ADDENDUM NUMBER I

DATE: February 9, 2026

PROJECT: Newark Valley Central School District 2023
Capital Project – Phase III
High School Air Conditioning

1 FIRST FLOOR POWER PLAN - AREA 1
E402-AD1 1/8" = 1'-0"

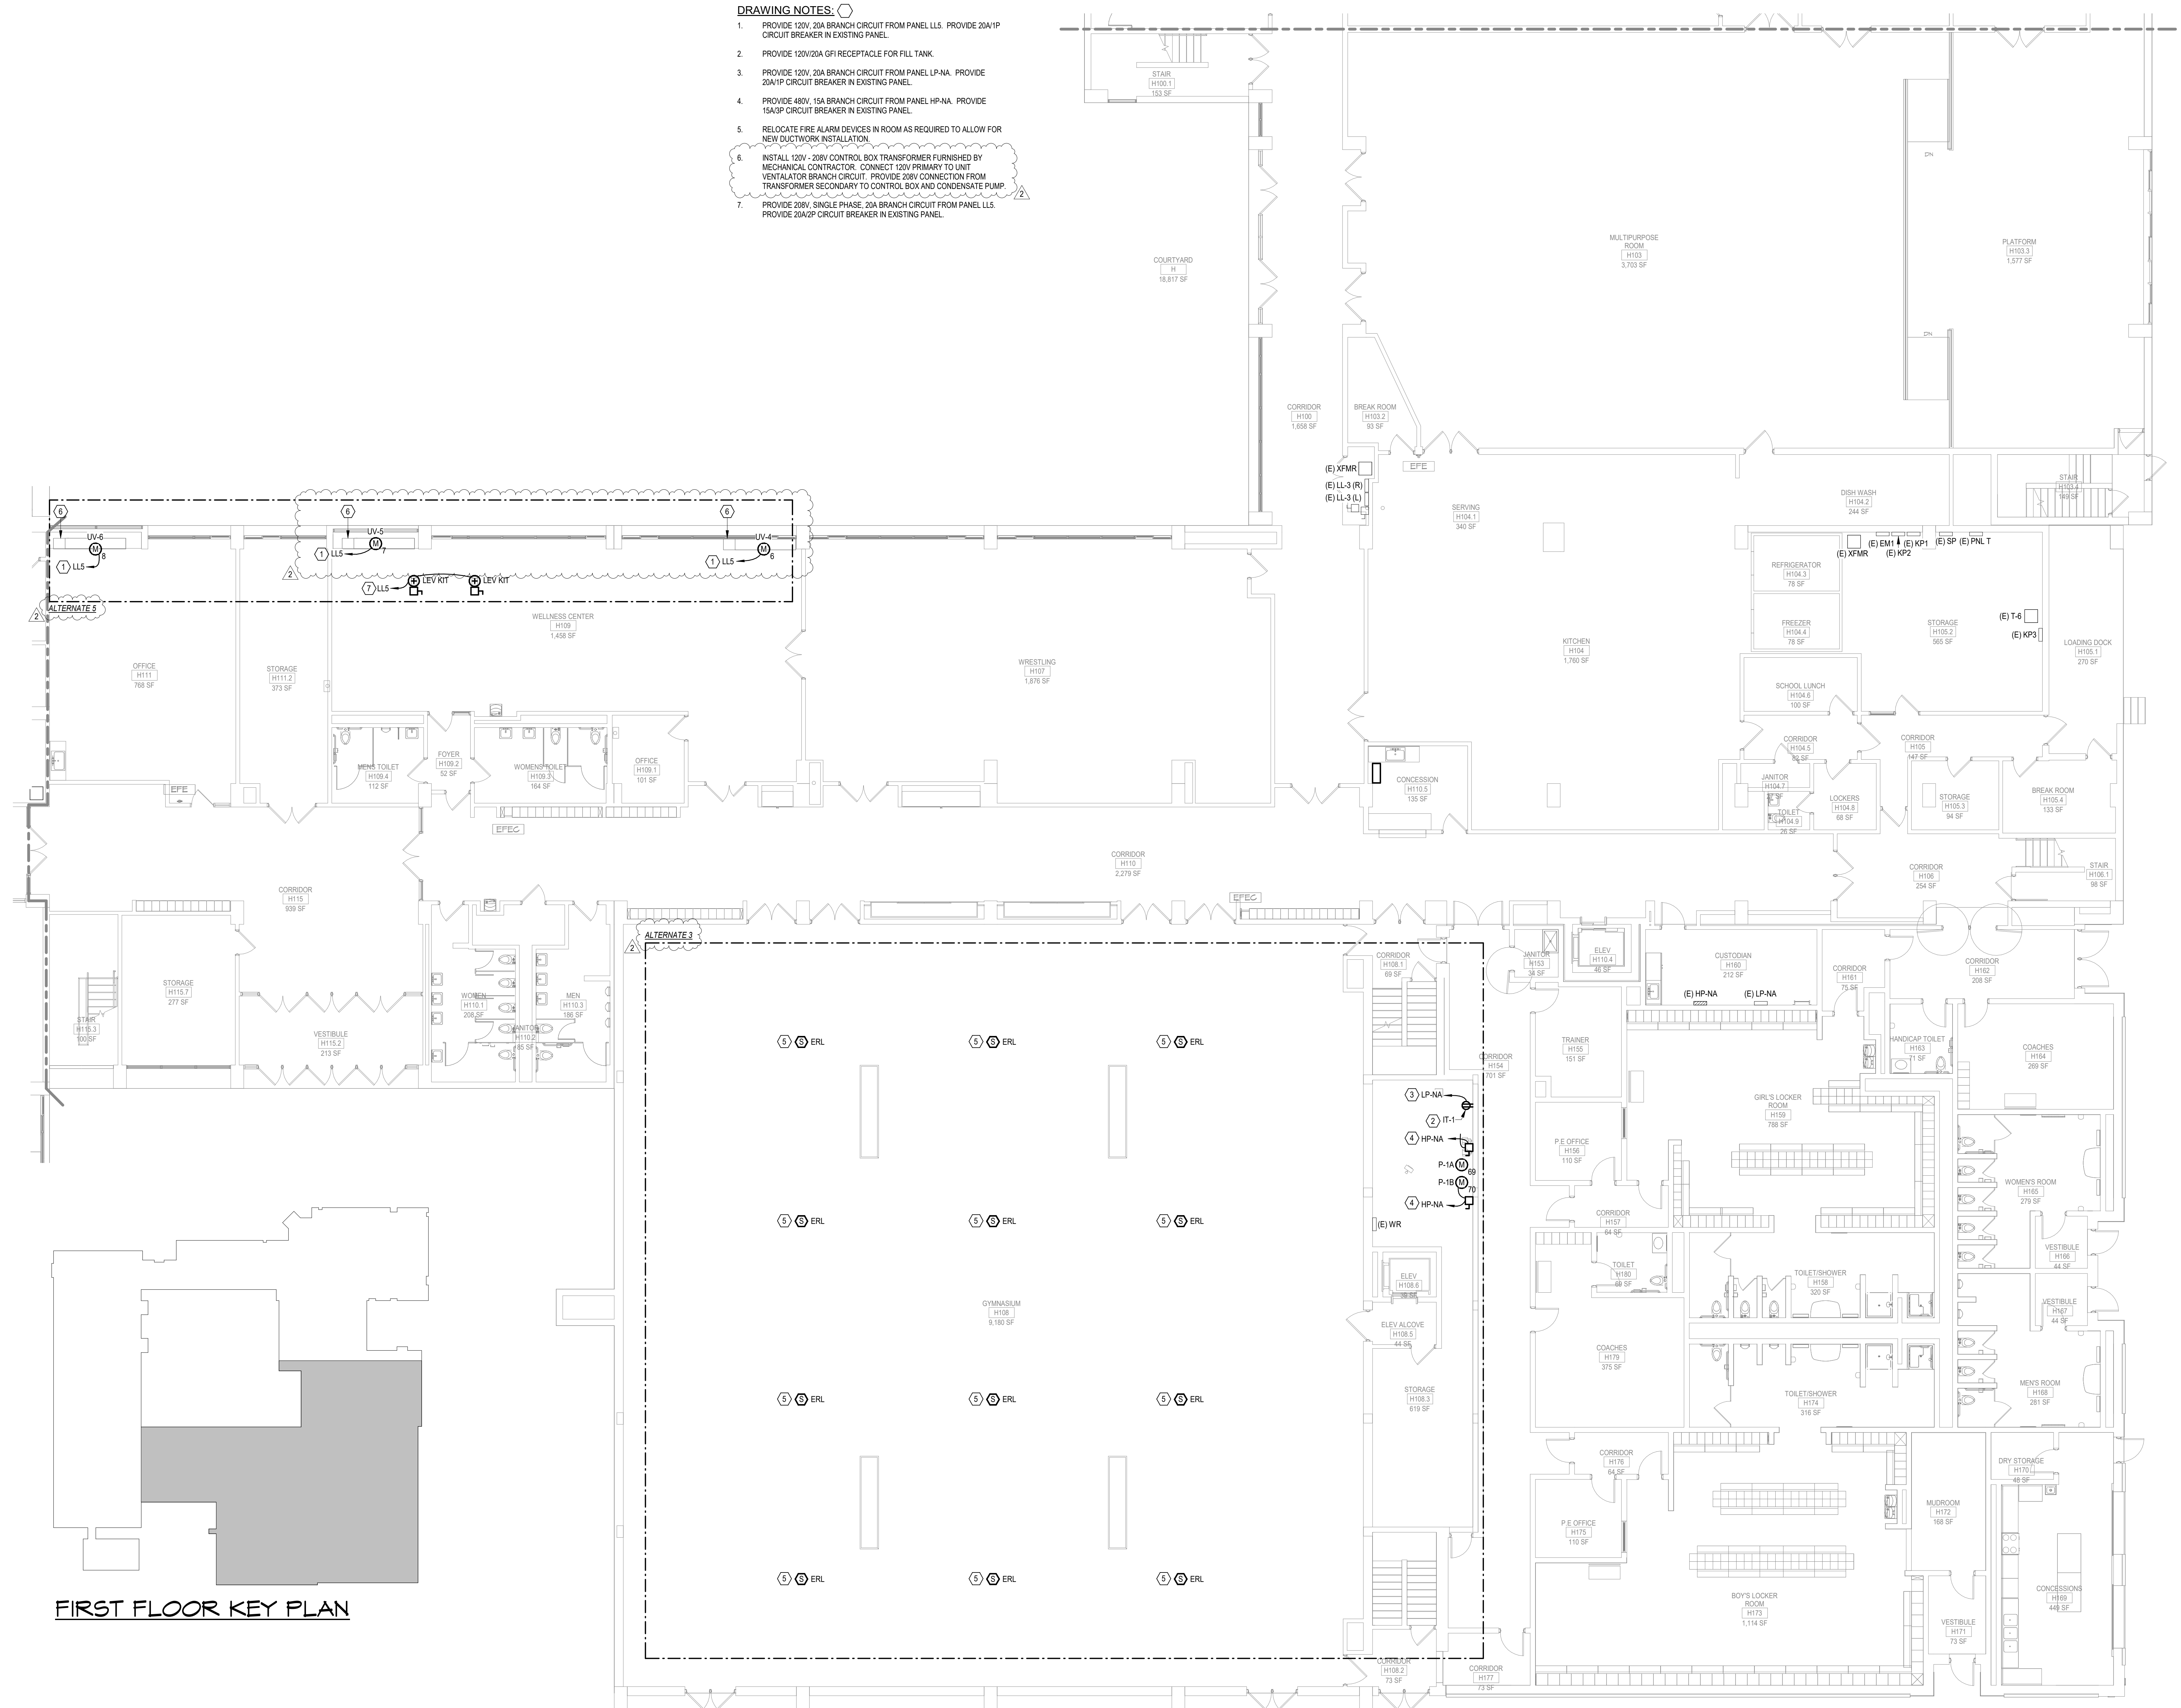
33. E401 – BASEMENT POWER & SYSTEMS PLAN - AREA 1
 - a. REVISE as shown on the attached drawing E401-ADI.
34. E402 - FIRST FLOOR POWER & SYSTEMS PLAN - AREA 1

- a. REVISE as shown on the attached drawing E402-ADI.
35. E403 - FIRST FLOOR POWER & SYSTEMS PLAN - AREA 2
 - a. REVISE as shown on the attached drawing E403-ADI.

1 SECOND FLOOR POWER PLAN - AREA 1
E405-AD1 1/8" = 1'-0"

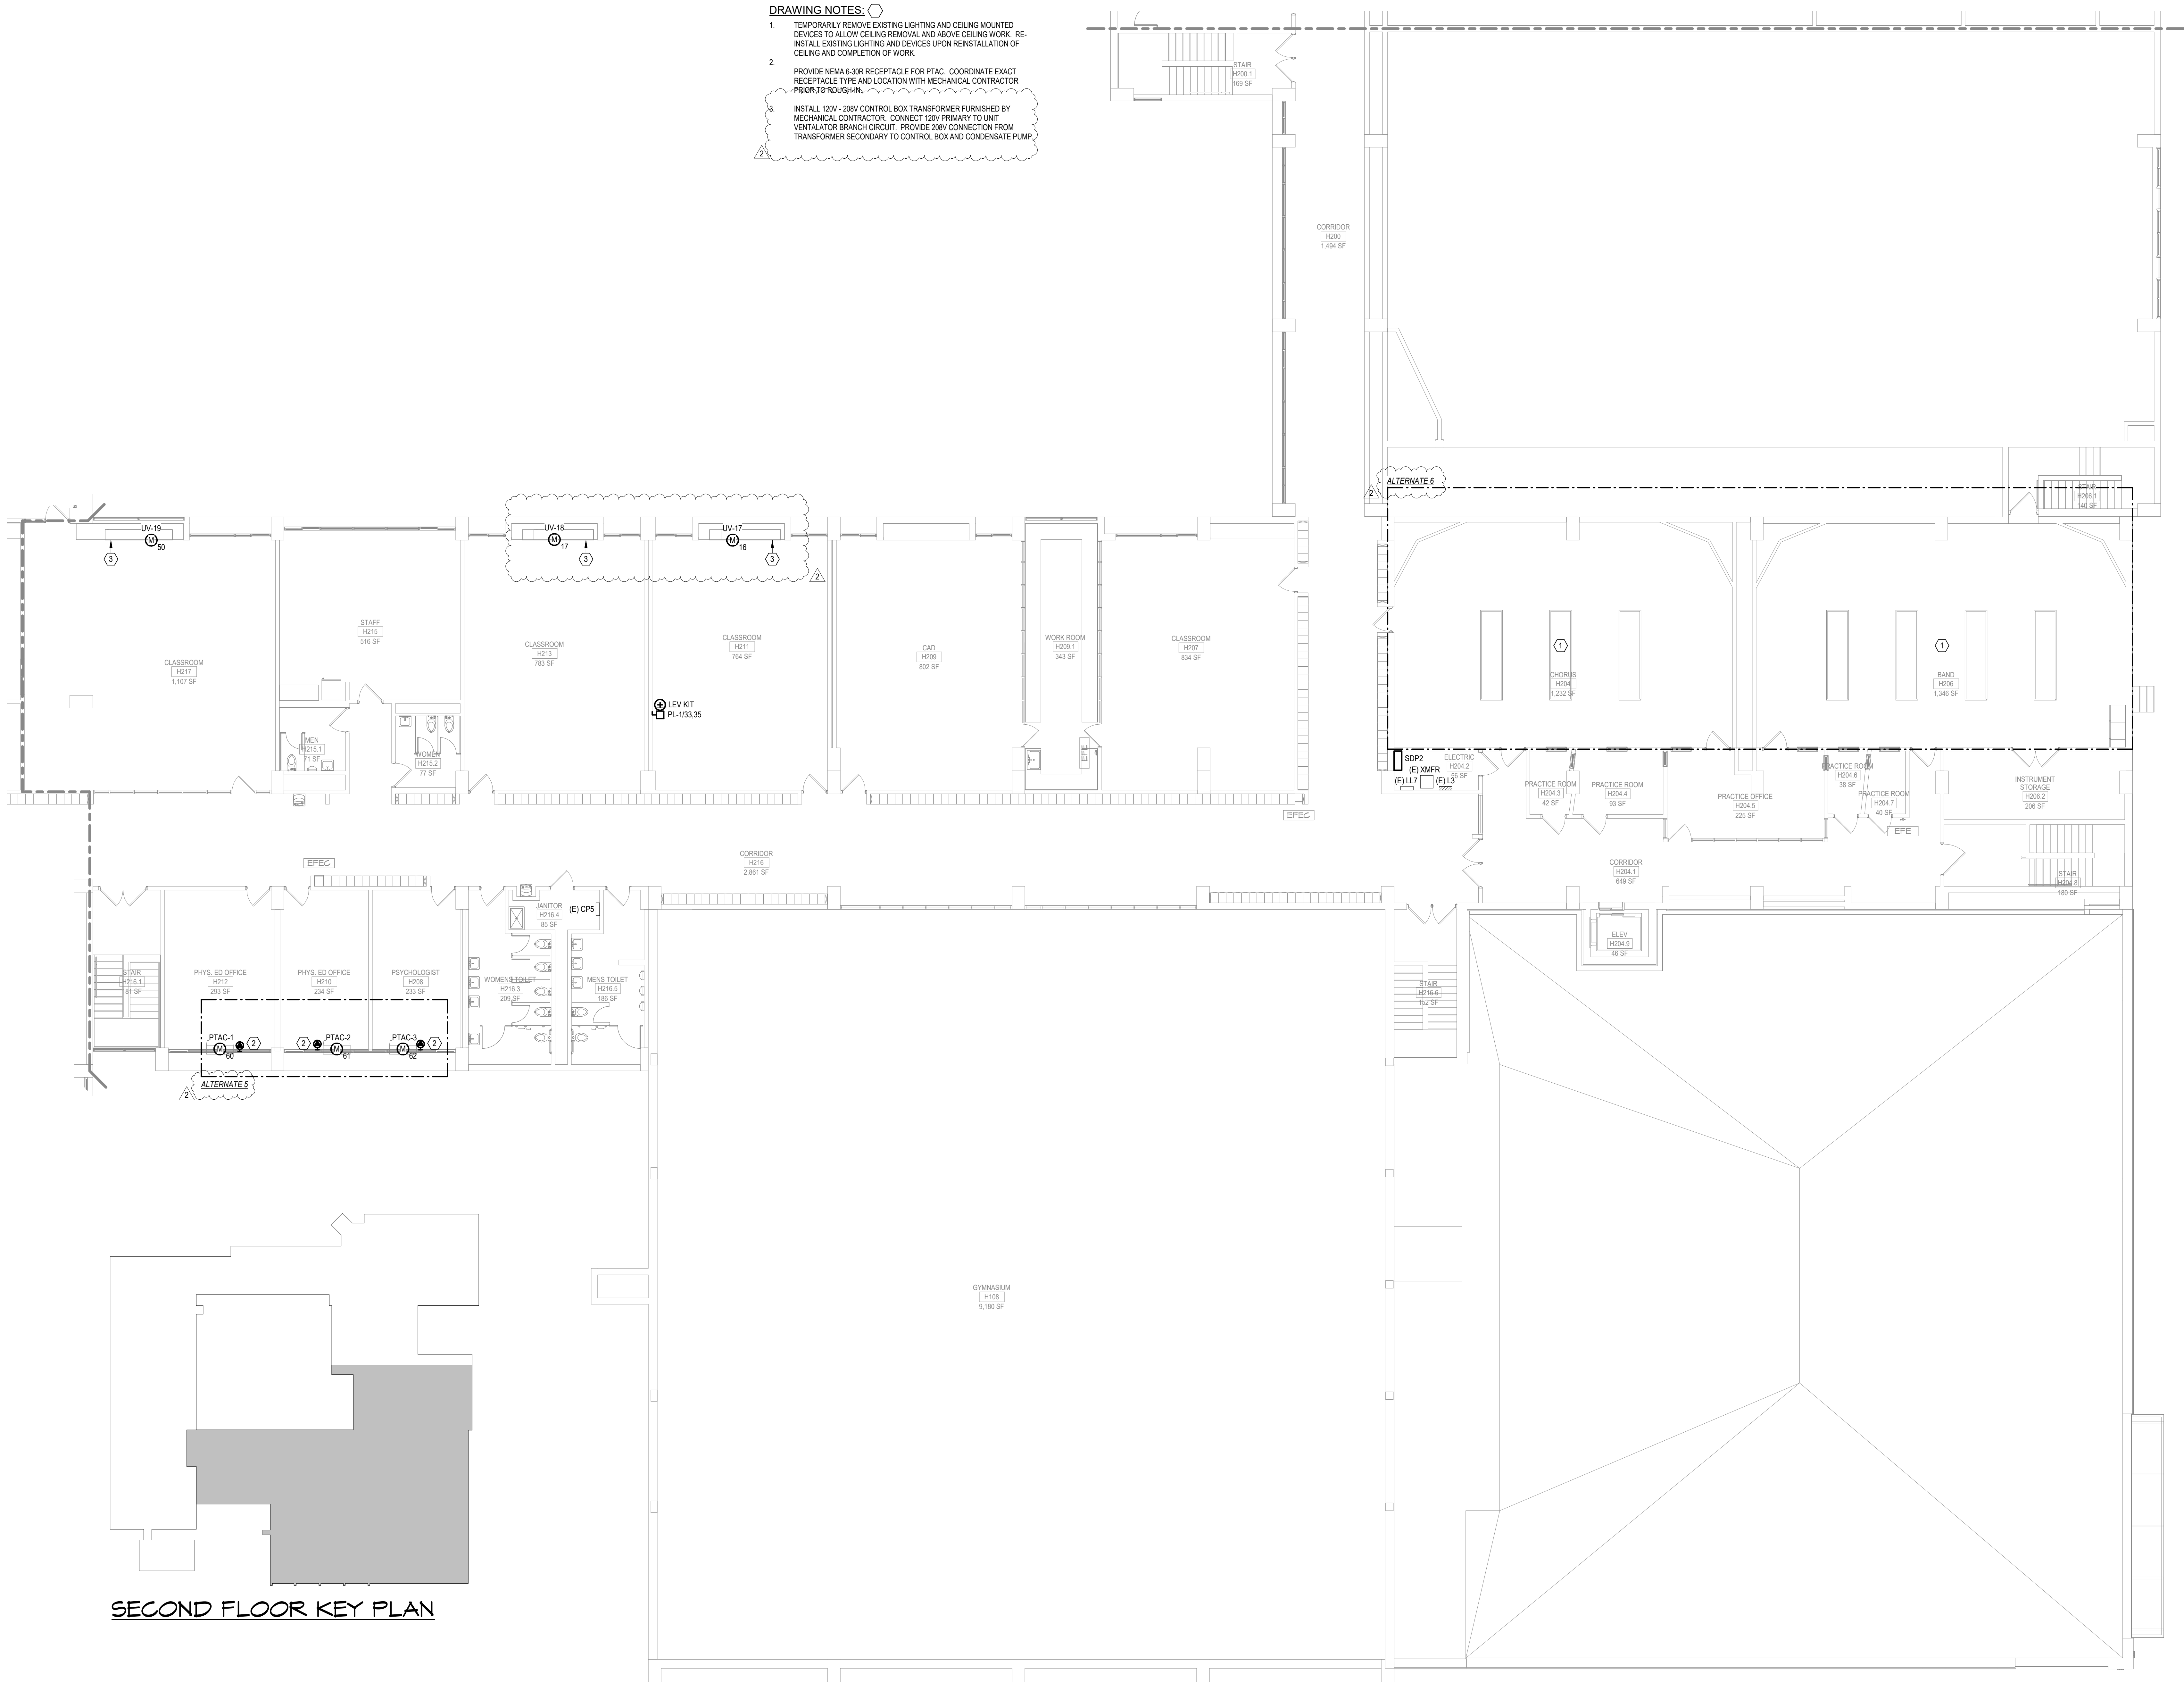
36. E404 - FIRST FLOOR POWER & SYSTEMS PLAN - AREA 3
 - a. REVISE as shown on the attached drawing E404-ADI.
37. E405 - SECOND FLOOR POWER & SYSTEMS PLAN - AREA 1

- a. REVISE as shown on the attached drawing E405-ADI.
38. E406 - SECOND FLOOR POWER & SYSTEMS PLAN - AREA 2
 - a. REVISE as shown on the attached drawing E406-ADI.
